April 1, 2022

Re: Remediation Workplan Addendum
WTX to EMSU Battery to Byrd Pump Segment Crude Oil Release
NMOCD Incident No. NOY1822242858
Unit P, Section 11, Township 20S, Range 36E
Latitude 32.583874, Longitude -103.317460
Lea County, New Mexico

REMEDIATION WORKPLAN ADDENDUM

TITLE:
PROPOSED SOIL REMEDIATION PLAN

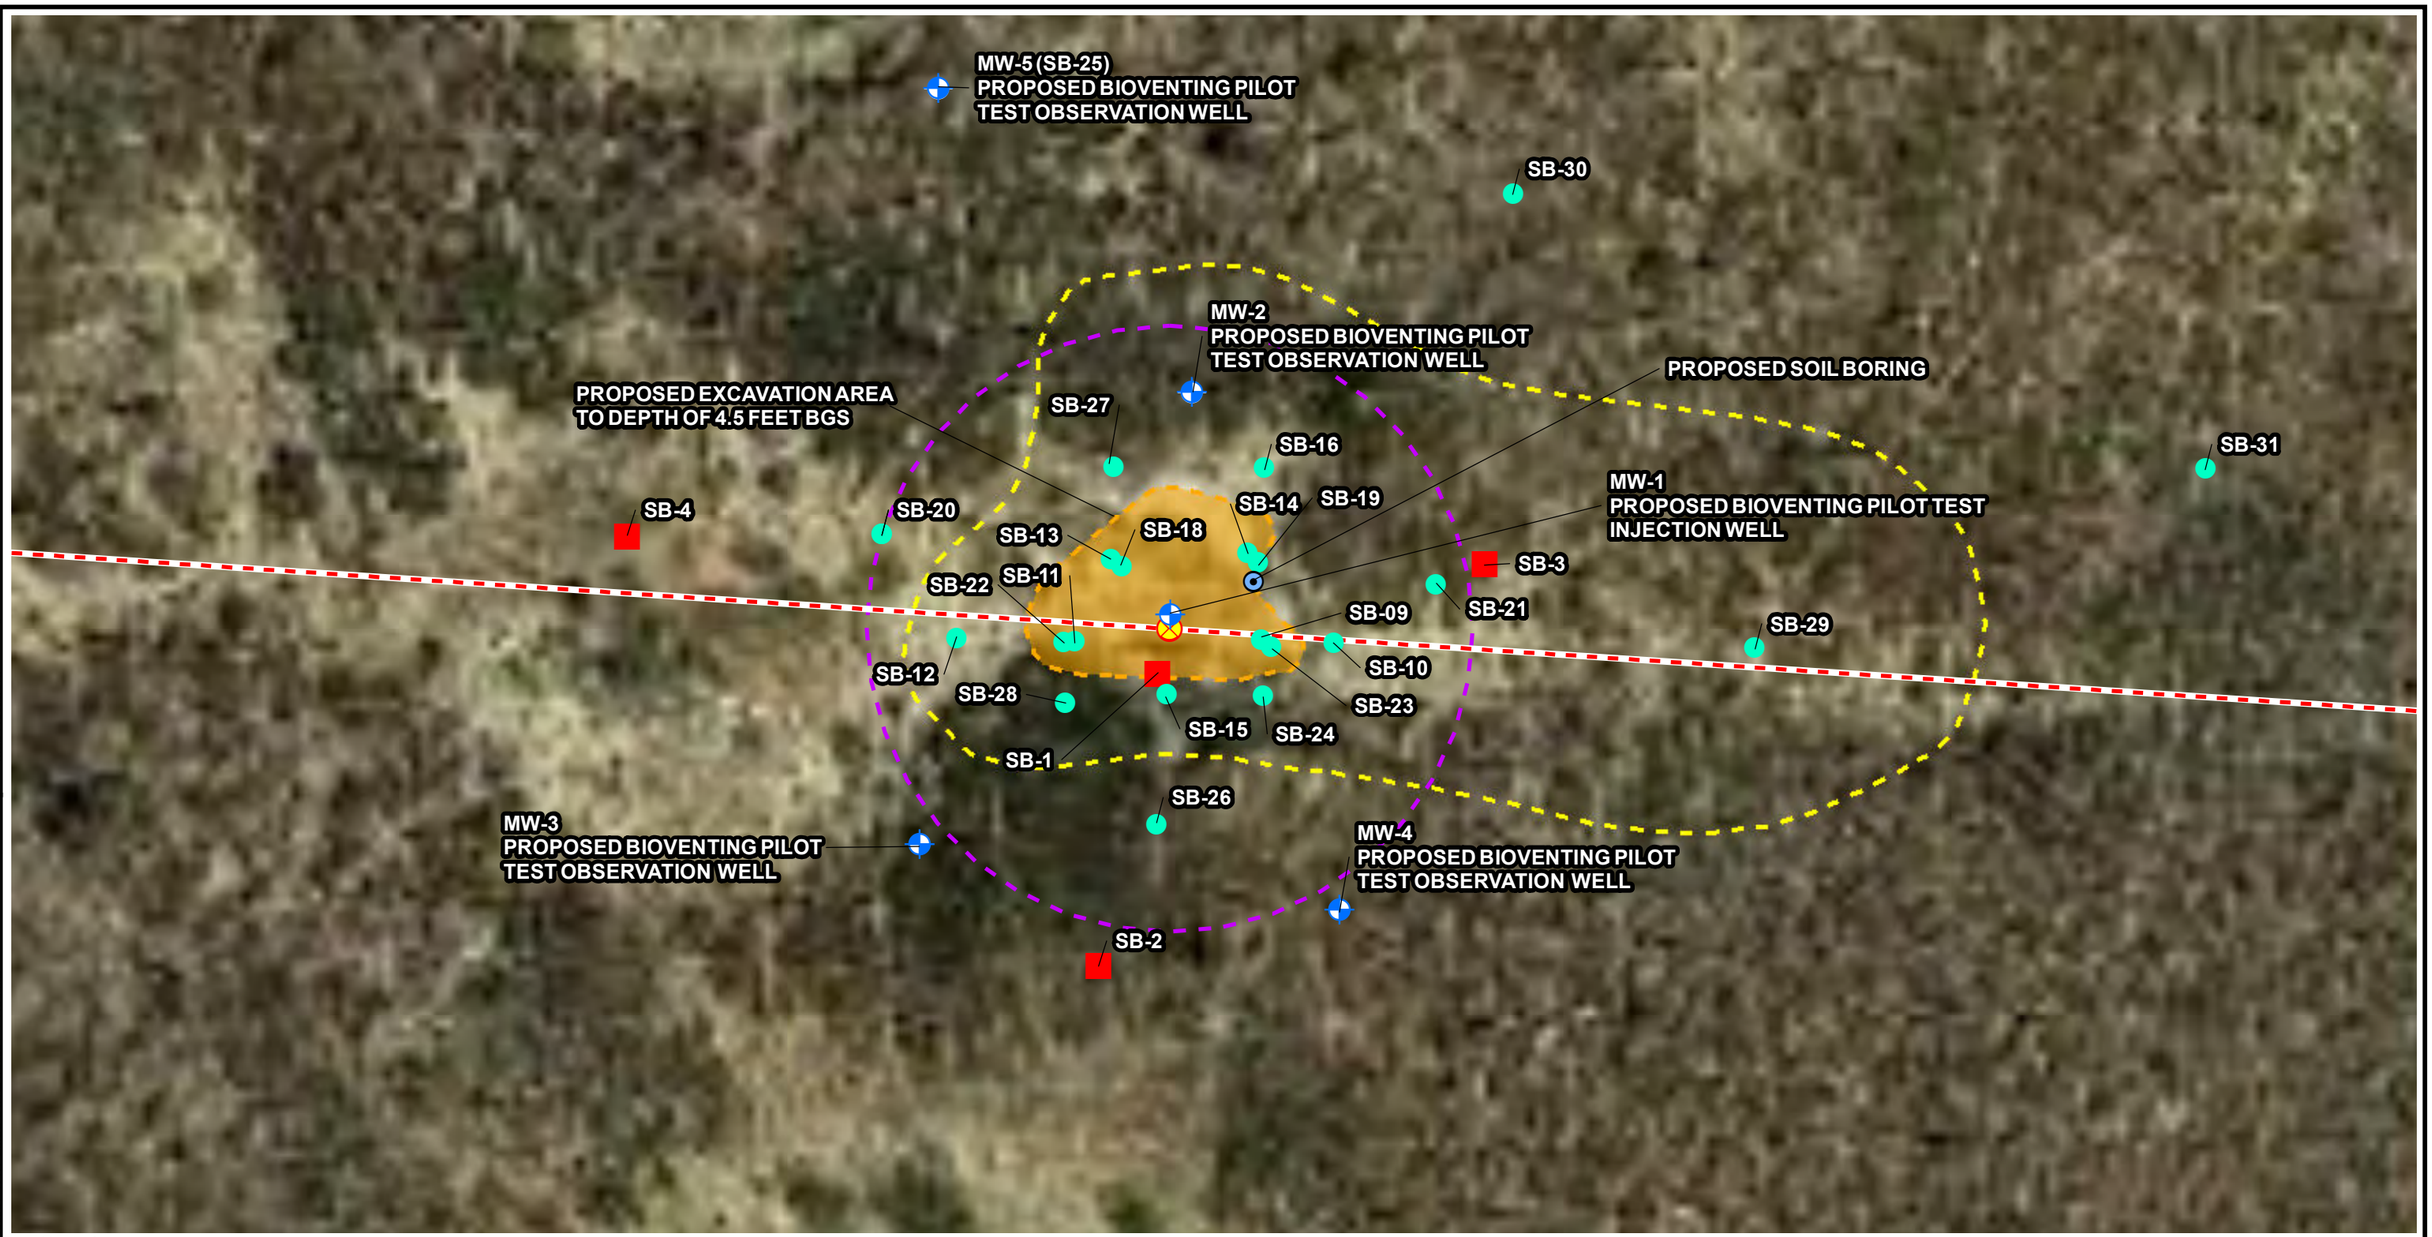
- Addition of clarifying language that the target treatment area of the final bioventing system, if installed, will include the full extent of TPH-affected soil beneath 4 feet bgs at the Site (defined by the yellow dashed line on Figure 1).

Excavation and off-Site disposal of surface soil with TPH concentrations above Closure Criterion will be conducted to an approximate depth of 4.5 feet bgs in accordance with Section 5.1 of the November 2021 SCR and RWP. The extent of surface soil with TPH concentrations above the Closure Criterion is depicted on Figure 1.

The locations of the proposed pilot test injection well (MW-1), the anticipated effective injection ROI of 50 feet, and the pilot test observation wells (MW-2, MW-3, MW-4, and MW-5) are shown on Figure 1. The latitude and longitude for the proposed pilot test injection and observation wells are summarized in the table below. The well construction log for pilot test injection well MW-1 and observation wells MW-2 through MW-5 are included in Appendix D.

As discussed above, if bioventing is determined to be effective based on the results of the pilot test, a full-scale bioventing system will be designed and proposed to NMOCD prior to being installed at the Site. The pilot test data and effective injection ROI will be used to determine the optimal design and operational parameters, including the number and location of bioventing injection wells to ensure treatment of the full extent of TPH-affected soil beneath 4 feet bgs at the Site as shown by the yellow dashed line on Figure 1. In other words, the bioventing injection wells will be located such that the effective ROI overlaps the entire area shown by the yellow dashed line on Figure 1.

PILOT TEST DIAGRAM

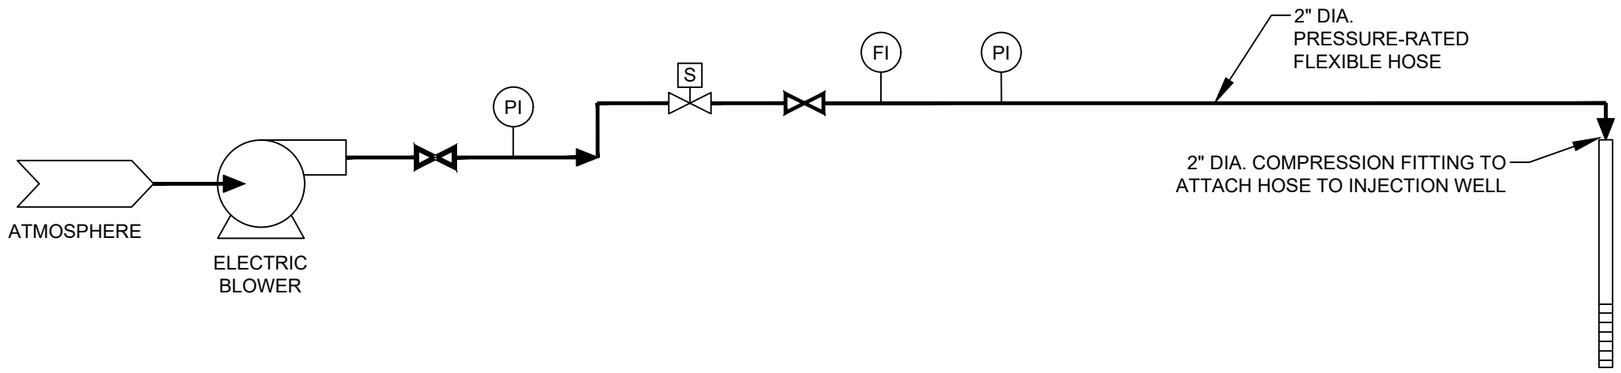
- Utilize a generator-powered blower to inject ambient air into release area well MW-1. The wellhead will be connected to the blower using 2-inch above-ground flexible hose and the wellhead will be sealed during injection activities using a 2-inch diameter compression fitting. A process flow diagram for the bioventing pilot test injection is shown on Figure 2. The air injection rate will range from 1 to 3 cubic feet per minute (cfm) per vertical foot of the MW-1 screen interval in the vadose zone (approximately 6 feet), or approximately 6 to 18 cfm.
